**AGENDA
CITY OF MAPLEWOOD
ENVIRONMENTAL AND NATURAL RESOURCES COMMISSION**

**MINUTES
CITY OF MAPLEWOOD
ENVIRONMENTAL AND NATURAL RESOURCES COMMISSION
TUESDAY, OCTOBER 25, 2022
7:00 P.M.**

City of Maplewood
Members of the City Council, Planning Commission, and ENRC
Attn: Elizabeth Hammond & Shann Finwall
1902 County Road B E
Maplewood, MN 55109

Westwood Professional Services, Inc., received the review comments via email from the City of Maplewood on 11/07/2022 regarding the Landscape Plan dated 10/24/2022 and the Tree Preservation Plan submitted 09/28/2022 for Maplewood Enclave Apartments. We have addressed these comments. In red below are our responses.

SHEET NUMBER: **C200**
 DATE: 11/11/2022
 PROJECT NUMBER: 0037066.00
 PREPARED FOR: **ENCLAVE DEVELOPMENT**
 300 33RD AVE E, SUITE 300
 WEST FARGO, ND 58078
 WESTWOOD PROFESSIONAL SERVICES, INC.
 11711/2022 - REVISED NO.

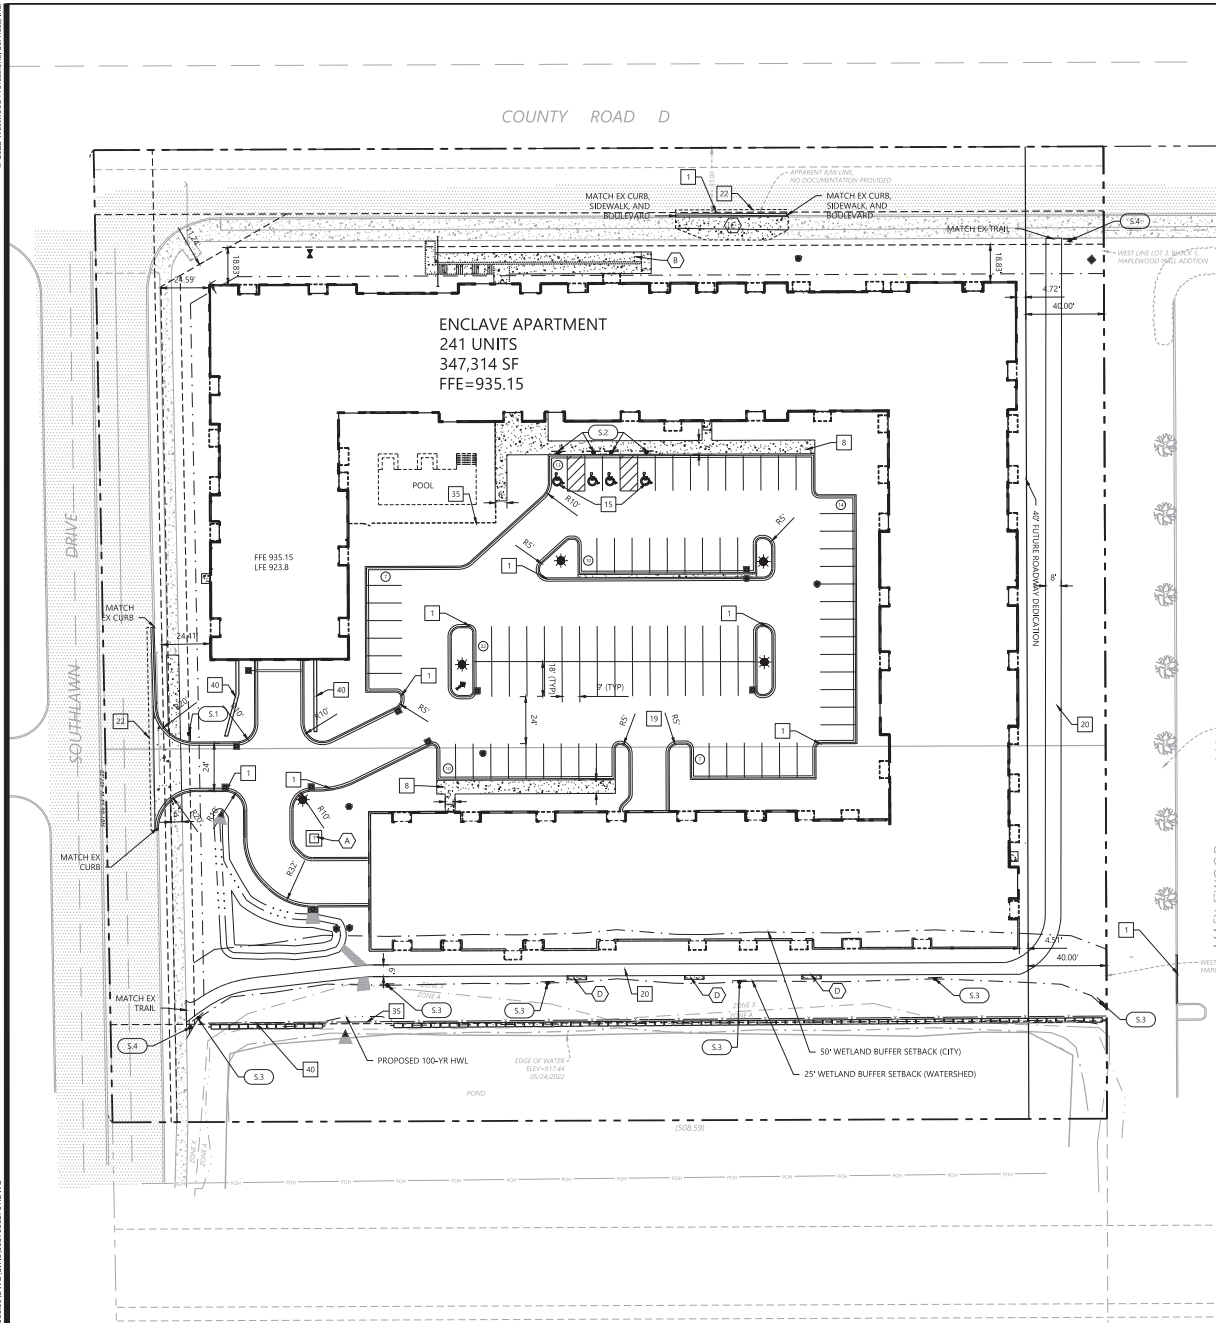
3. Tree Replacement: The landscape plan shows 42 new trees, totaling 105 caliper inches of replacement trees. This is 61 caliper inches less than City code requires. *RESPONSE: Noted, updated landscape plan shows a deficiency of 46 caliper inches. Payment to tree fund of \$2,760 will be made. See Sheet L100*

- 4) Revised Landscape Plan: The revised plan must identify 105 caliper inches of additional tree replacement. Alternatively, the applicant must pay into the **City's tree fund (see below)**. *RESPONSE: the revised landscape plan shows a 46 caliper inches deficiency, payment to City's tree fund will be made.*

- 5) Tree fund: The applicants must submit a tree fund payment in the amount of \$60 per caliper inch of replacement tree that cannot be planted on site. Since 105 caliper inches of trees are proposed to be planted on the site, the **applicants would owe the City's tree fund \$3,660 (166.2 caliper inches of required tree replacement – 105 caliper inches of trees planted on the site = 61 caliper inches of trees not planted on the site x \$60 = \$3,660)**. *RESPONSE: Payment of \$2,760 to be made to tree fund (46 caliper inches deficiency x \$60= \$2,760)*

L102

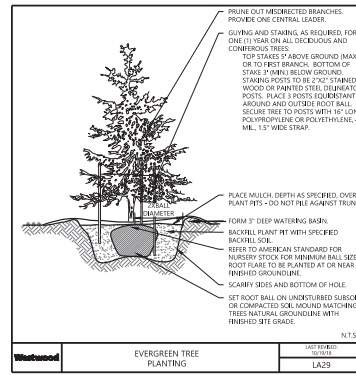
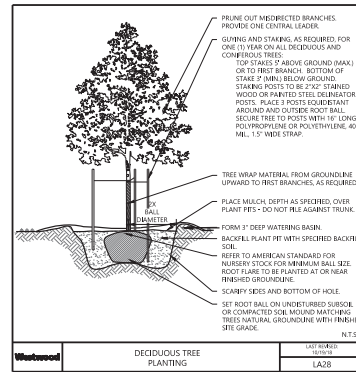
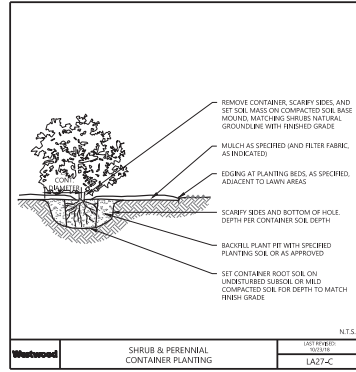
- a) **Native Plugs:** Include native plugs to be installed within the 25-foot re-established wetland buffer. Currently the landscape plan identifies a pollinator seed mix. Using plants rather than seeds hastens establishment and provides a better chance of successful establishment. The applicants should plant all plugs, or a mix of plugs and native seed mix in this area. *RESPONSE: The first 10' of the wetland buffer (the 10' closest to the wetland) will be planted with a mix of plugs and overseeding to assist in quick establishment and reduce erosion. The remaining portions to be seeded.*

- b) **Seed Mix:**
 1. Provide information on the percentages and species of native seed mix. *RESPONSE: See sheet L102 Wetland Buffer Mitigation Plan for the seed mix data sheet.*

2. Provide information on the maintenance required for the planting year, and years two and three, addressing what maintenance activities will be required and what entity (developer, owner, etc.) will take on

the responsibility. *RESPONSE: See sheet L102 for maintenance info. Further information to be provided at a later date.*

Myth Maplewood Delineation Site Photograph

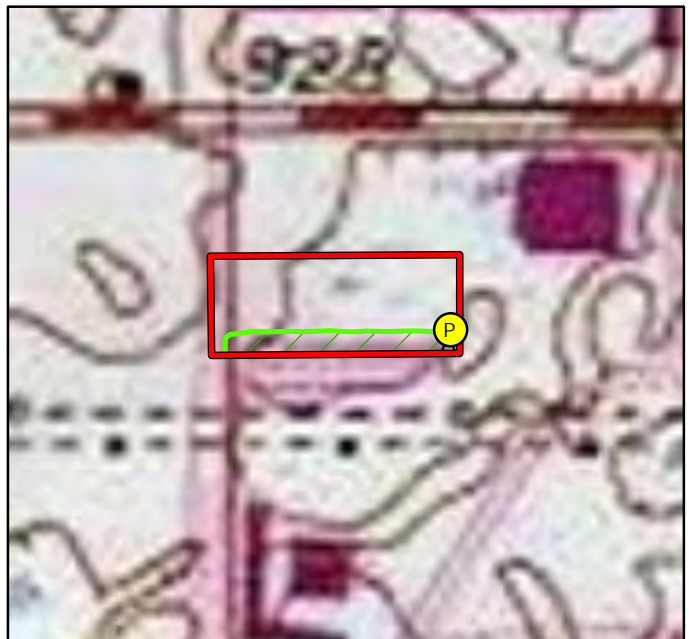
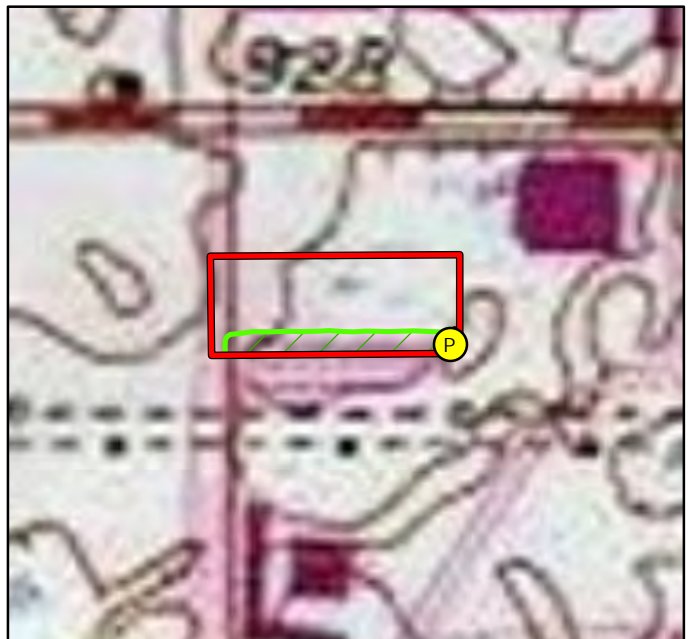
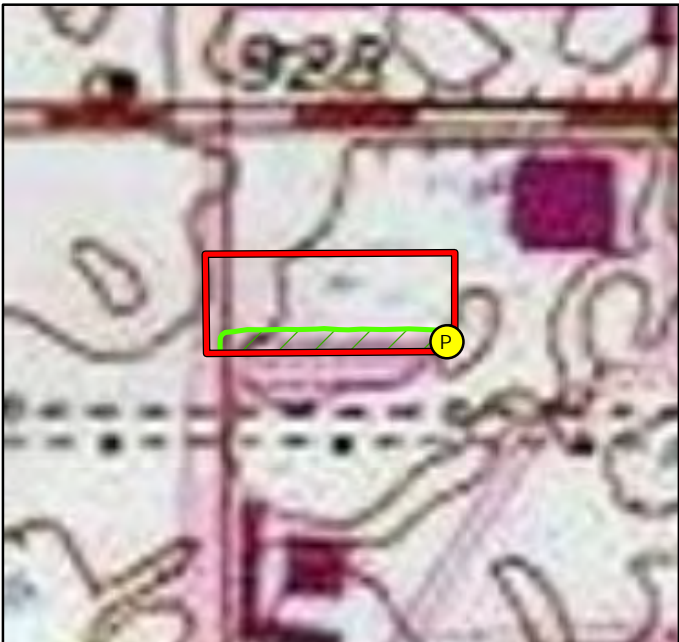
Image 1. Debris and invasive species within the existing buffer adjacent to the parking lot.

Image 2. Crumbling infrastructure and erosion along the existing parking lot creating safety hazards.

Image 3. Existing building and parking lot along pond.

Image 4. Existing building and sidewalk abutting pond.
